**Bullard Energy Center  
Application for Certification  
Data Request Responses  
06-AFC-8**

**TECHNICAL AREA: AIR QUALITY**

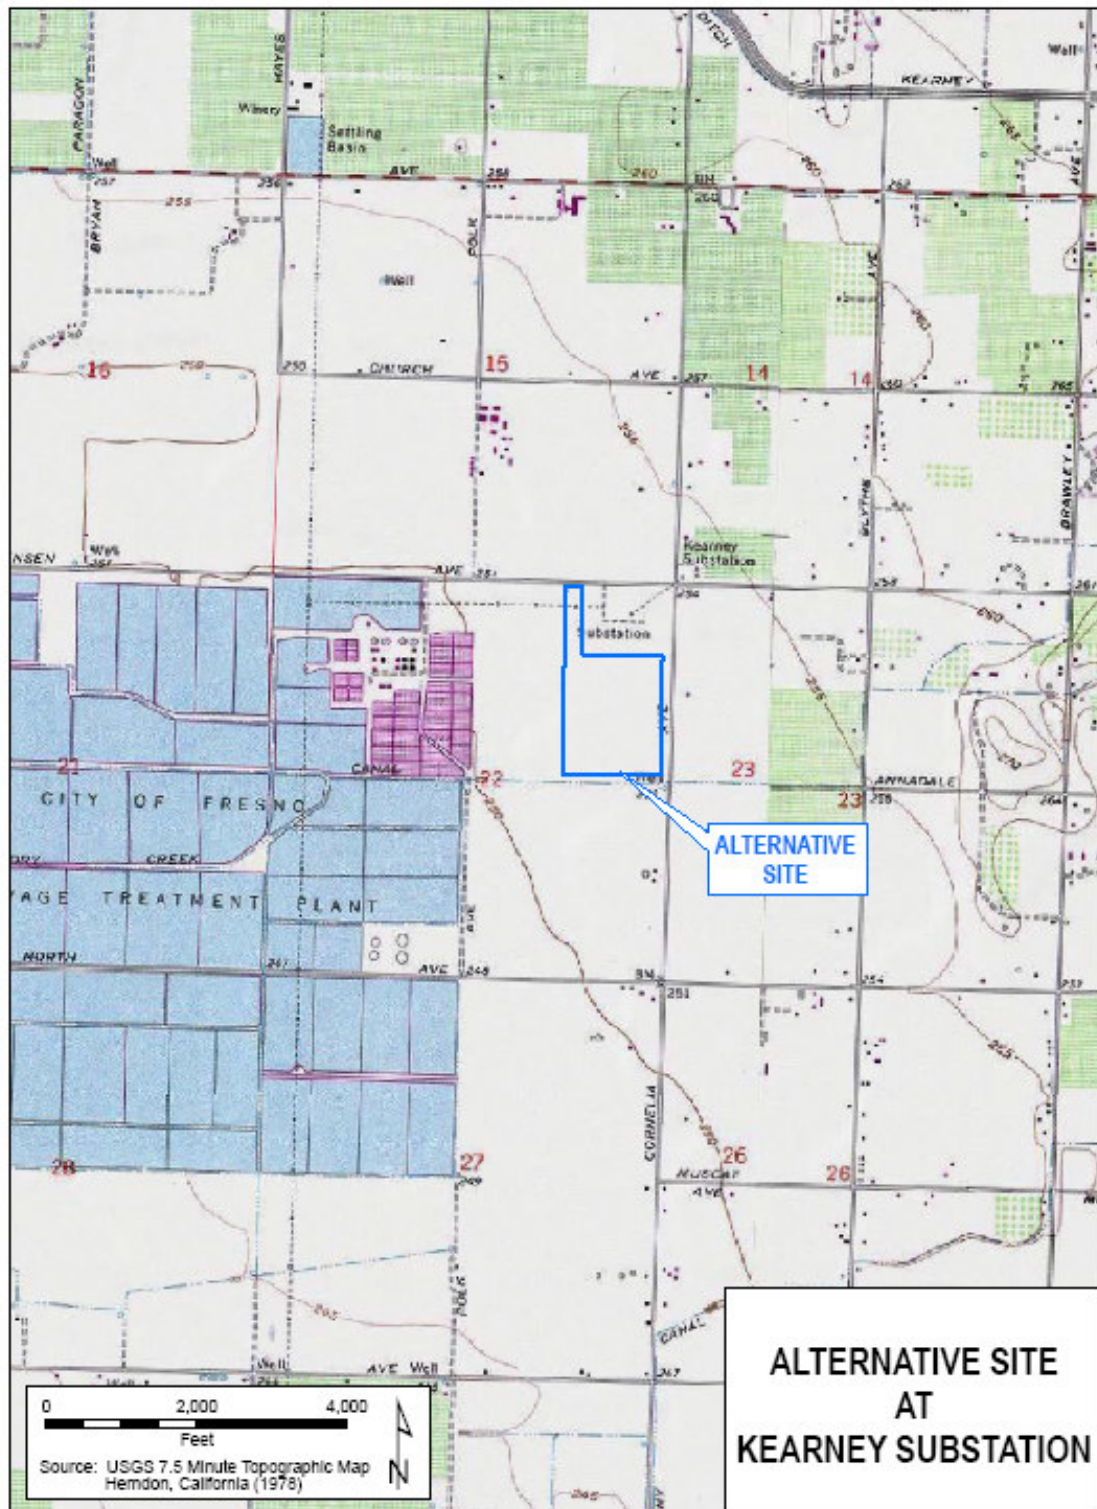
**Data Request 23 Rev:** Please provide a detailed description (including a map, acreage, elevation, topography) of the alternative sites that were considered.

The Kearney Substation is located in Fresno County on the southwest corner of Cornelia and Jenson. The site considered was immediately south of the substation on land owned by the City of Fresno and is part of its wastewater treatment plant complex. The City of Fresno had previously stated that it would not make the land available for a power plant. Thus this site was also not available for construction of a power plant. Had this land been available, PG&E would have required a reconducturing of the line from the Kearney Substation to the Herndon Substation which would have been prohibitively expensive for a small power plant. Refer to the below figure titled Alternative Site at Kearney Substation.

1946 *Herndon* Quadrangle, showing no buildings within 50 feet of Gas Route B west of Highway 99.

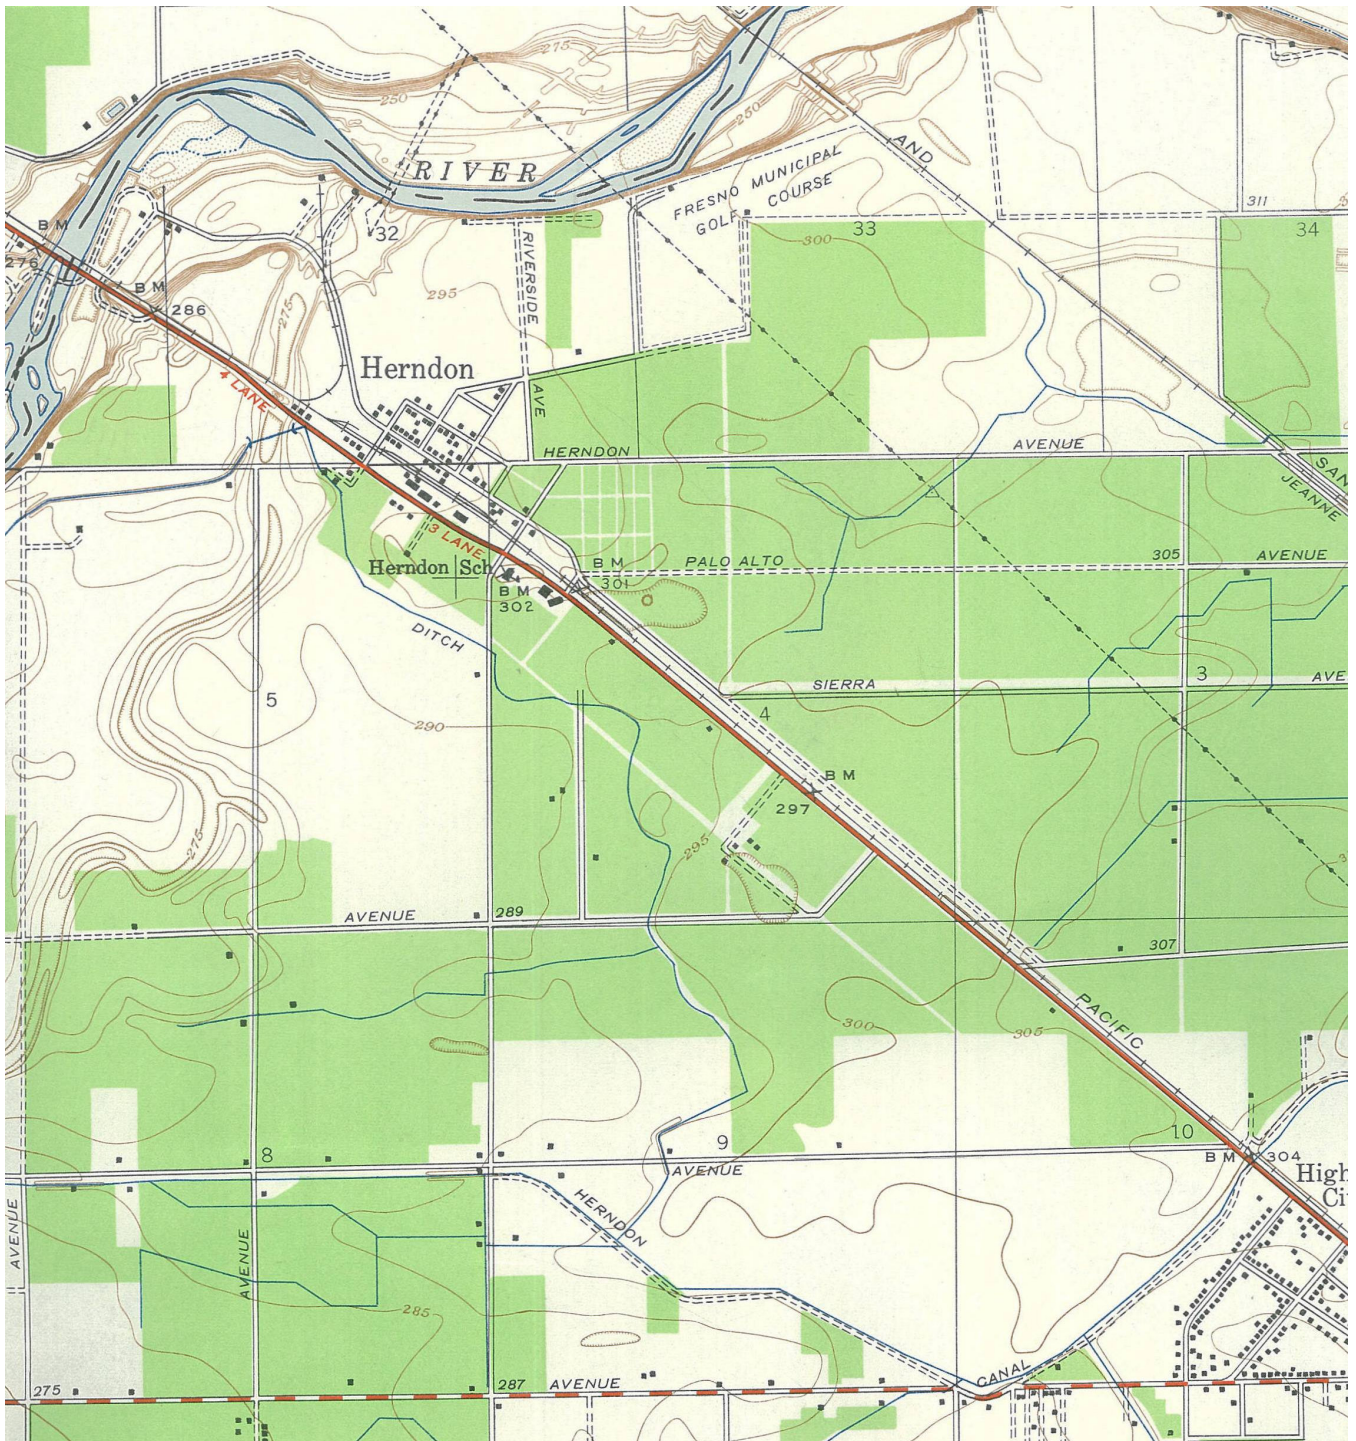
- a. If the two routes have been surveyed, please describe the results of the survey and if applicable: discuss the eligibility of any identified cultural resources for inclusion in the California Register of Historical Resources (CRHR), any potential construction-related impacts to CRHR-eligible cultural resources, and recommended mitigation measures. Please record any discovered or newly identified cultural resources on a Department of Parks and Recreation (DPR) form 523 and provide a copy of the form.

- b. If Gas Routes B and C have not been surveyed for cultural resources, please conduct cultural resource surveys for both routes and provide the results. If cultural resources are identified: address their eligibility for inclusion in the CRHR, potential construction-related impacts to the CRHR-eligible resources; and if applicable, recommended mitigation measures. Please record any discovered or newly identified cultural resources on a DPR 523 form and provide a copy of the form.

Both pipeline routes have been surveyed for archaeological resources. No archaeological resources were discovered along these routes. However, much of the pipeline routes lie along developed land, and, as a result, ground visibility was often poor.

Gas route B has not been surveyed for historic structures. However, based upon USGS *Herndon Quadrangles* from 1946 and 1964, there were no structures in this area at those times. Therefore, the existing structures are less than 45 years old and not considered historical resources. In addition, current aerial photography shows that there are no resources within fifty feet of the middle of N. Golden State Boulevard along Gas Route B. Copies of these USGS quadrangles are attached.

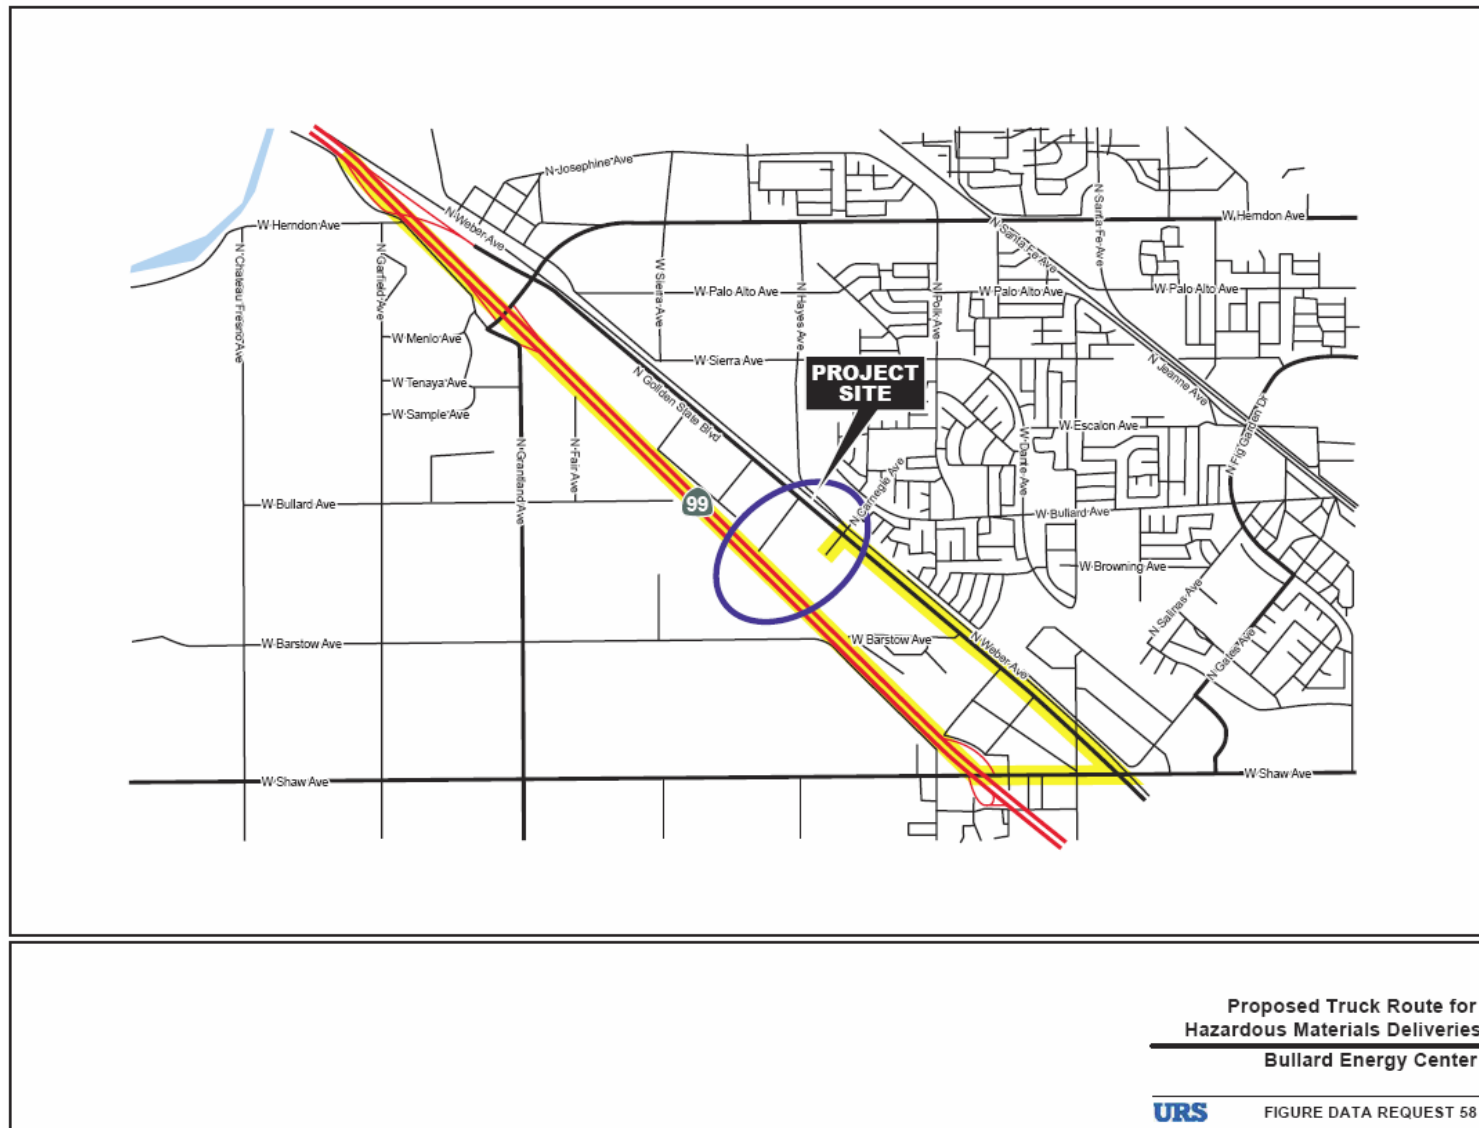
Please describe the proposed truck route for hazardous material deliveries and provide a detailed map of the hazardous material route from the appropriate freeway exit to the facility. For the truck route, please discuss:

- any road hazards such as railroad crossings, sharp curves, and intersections without traffic control such as signals, yield or stop signs, etc;
- the land uses along the route; and
- the location of any sensitive receptors along the route such as schools, hospitals, commercial or housing development, etc., affected by hazardous material deliveries.

a – Based on the traffic field reconnaissance survey, there are no road hazards identified to and from SR-99, the Shaw Avenue interchange, along Golden State Boulevard and the project site. See detailed map provided on the following page.
